**AMENDMENT 5**

**Invitation for Bid (IFB)  
UOG IFB No. B23-01**

UOG INVITATION FOR BIDS NO. B23-01:  
MULTI-STEP SEAL BID FOR CONSTRUCTION SERVICES

**QUESTION & ANSWER SHEET NO. 3**  
**July 25, 2023**

# E501

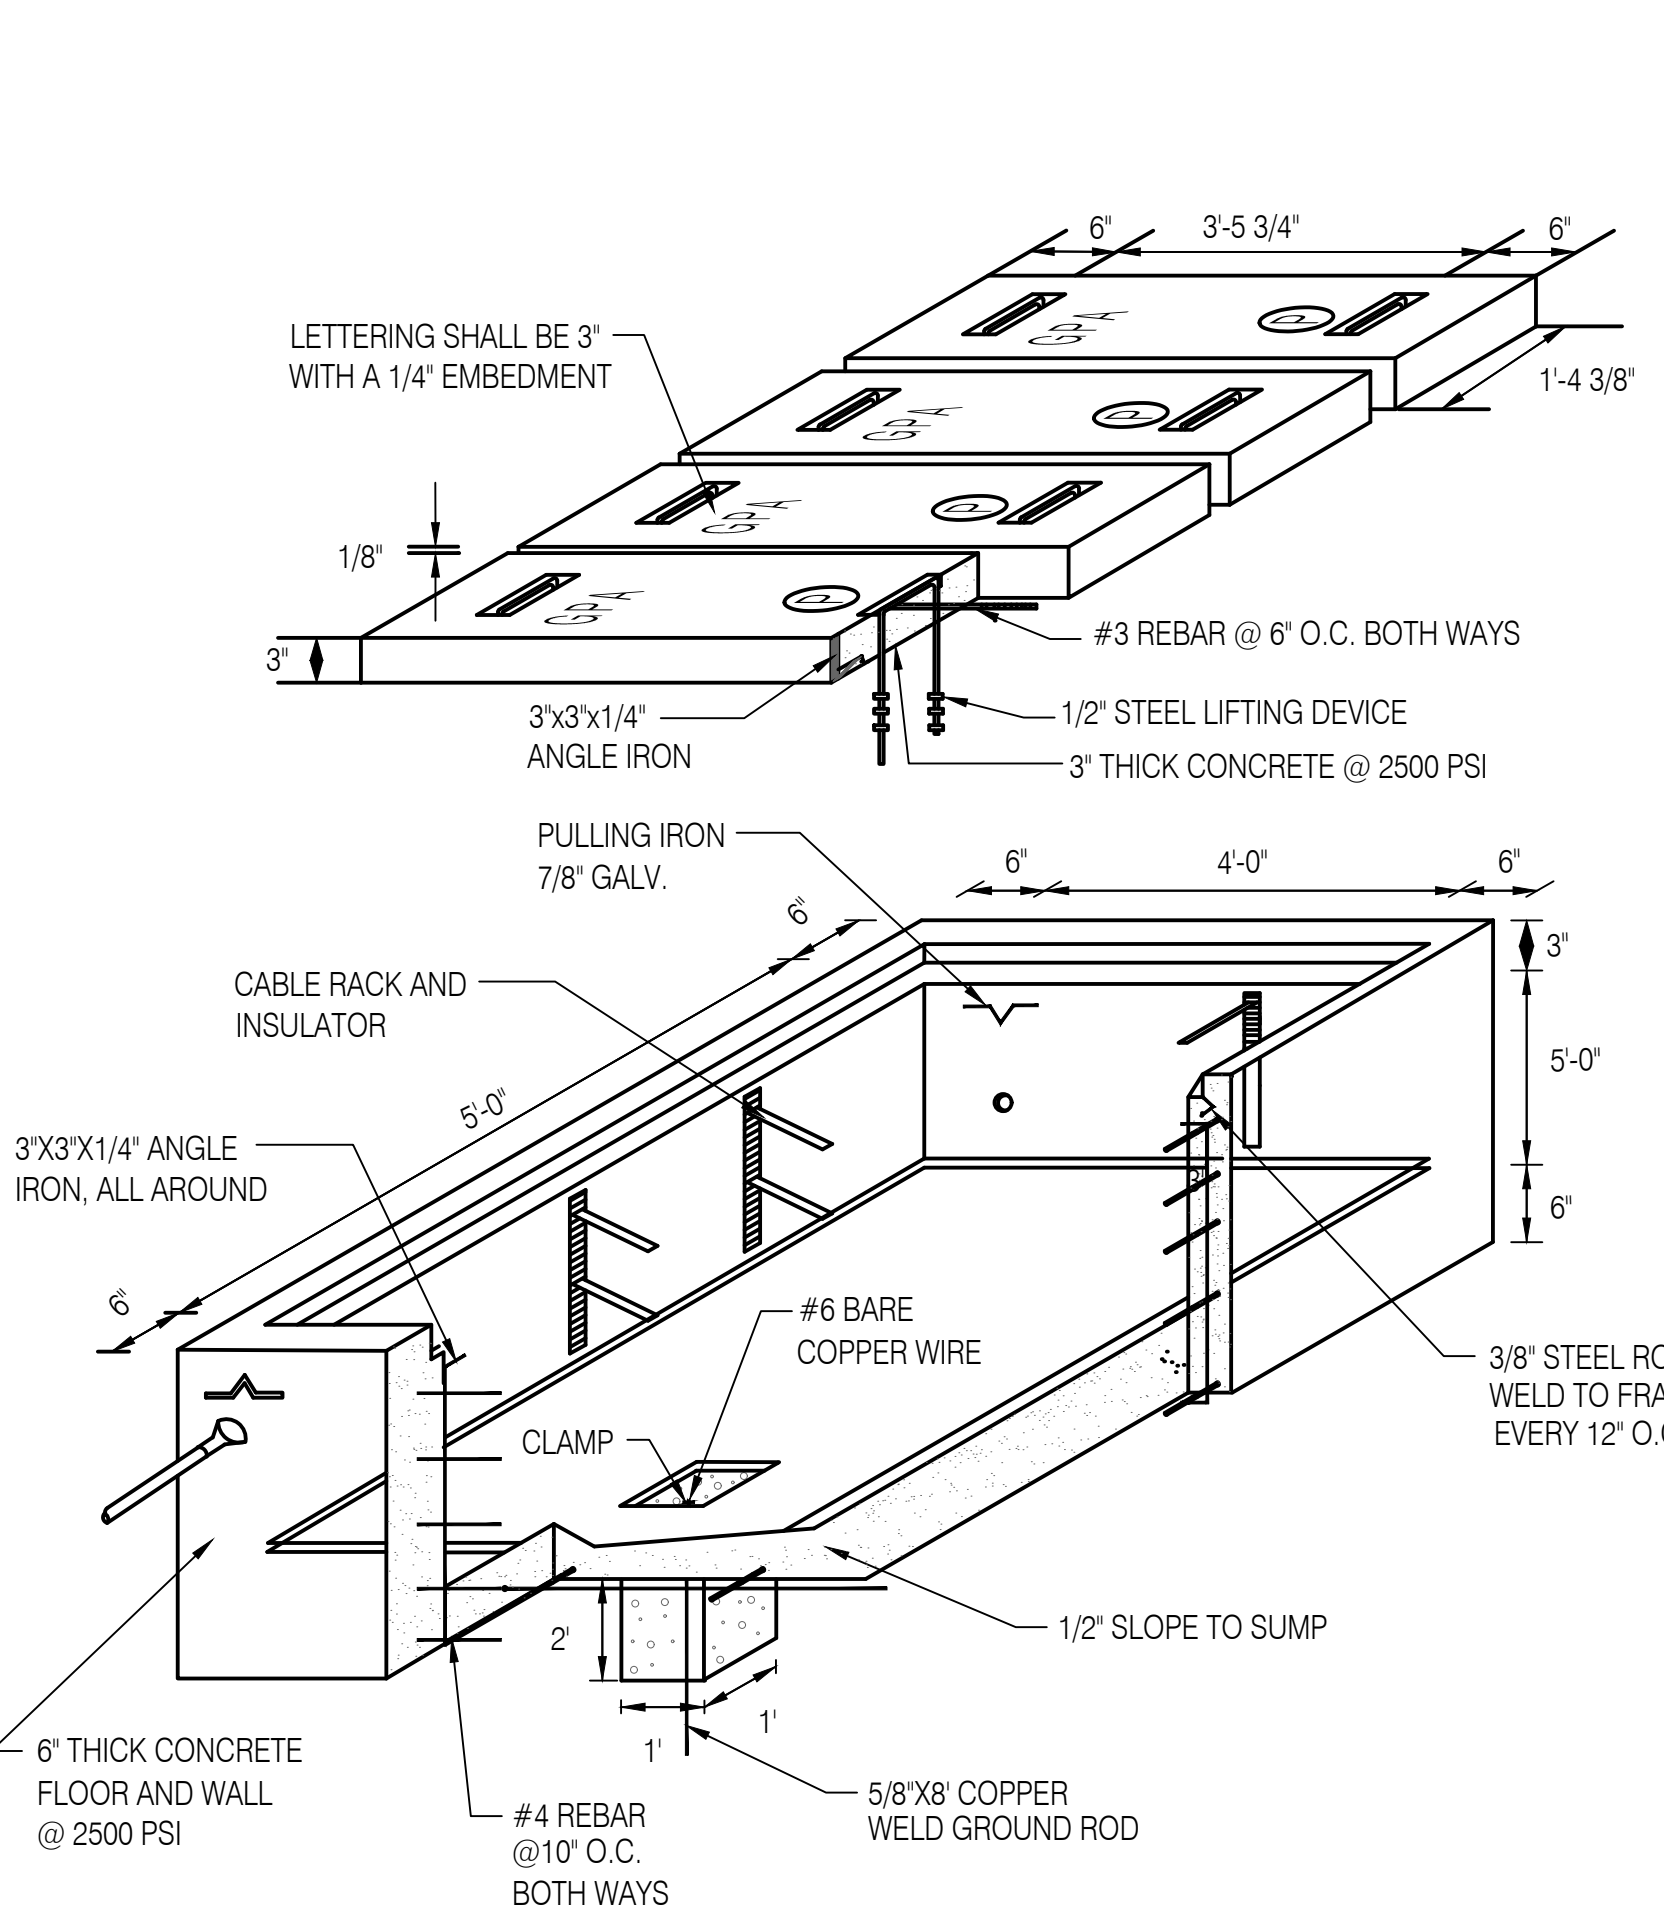
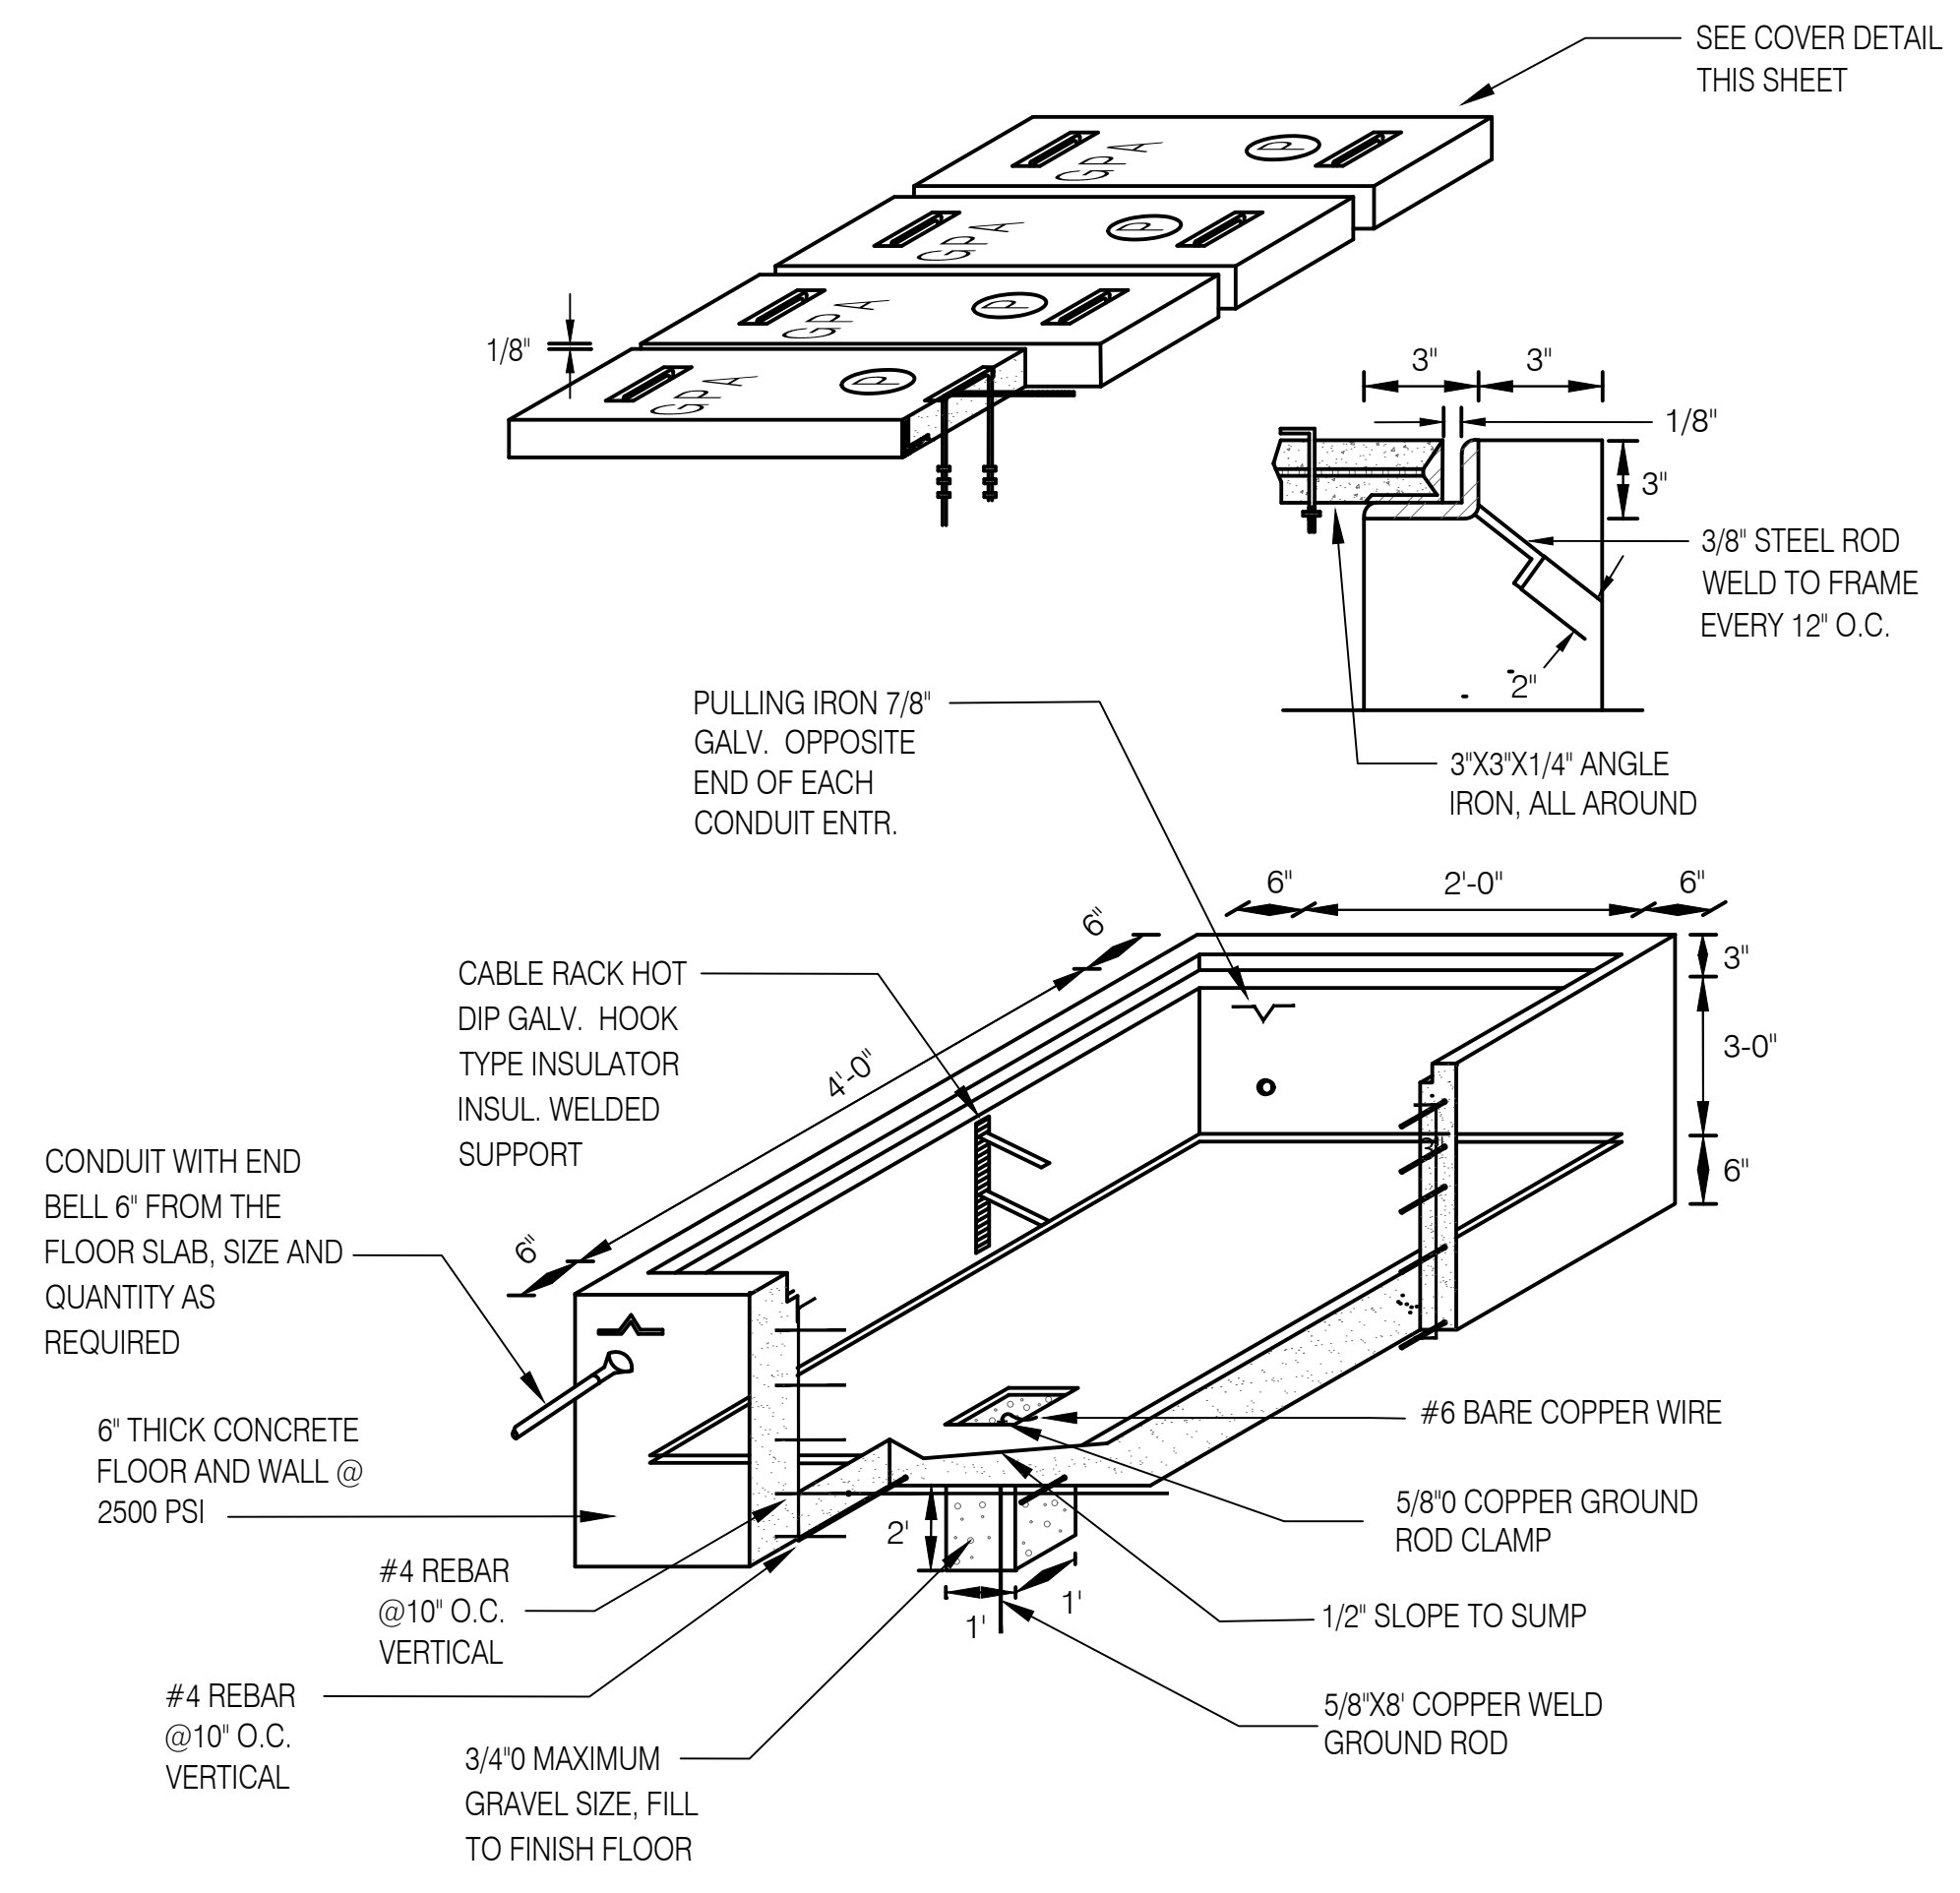
Please confirm ground rod size to be used

Please confirm if this is a man hole or a hand hole as compared to 2ES101.

Handhole
